L3 AMPLIFIERS

1.001 This Issue 2, addendum to Section E44.591.2, Issue 1, dated July, 1955, clarifies and restricts information that was included in the Issue 1, of Addendum E44.591.2 concerning the line amplifier GAIN ADJ switch.

Fig. 13 — Thermal Noise at Line Amplifier Output

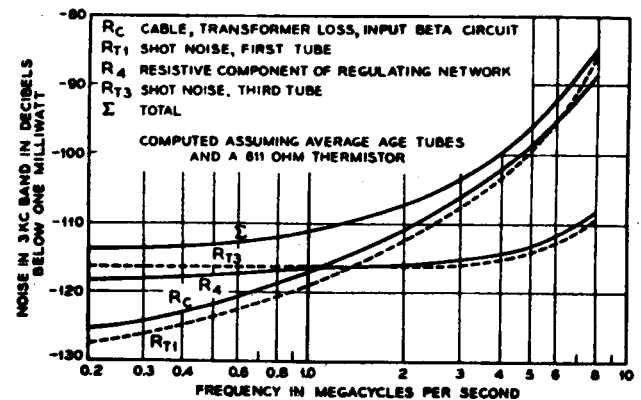
1.002 Also included in this addendum is Fig. 13, referred to in Paragraph 6.01, but which was omitted from Issue 1 of Section E44.591.2.

Paragraph 6.01 — add Fig. 13.
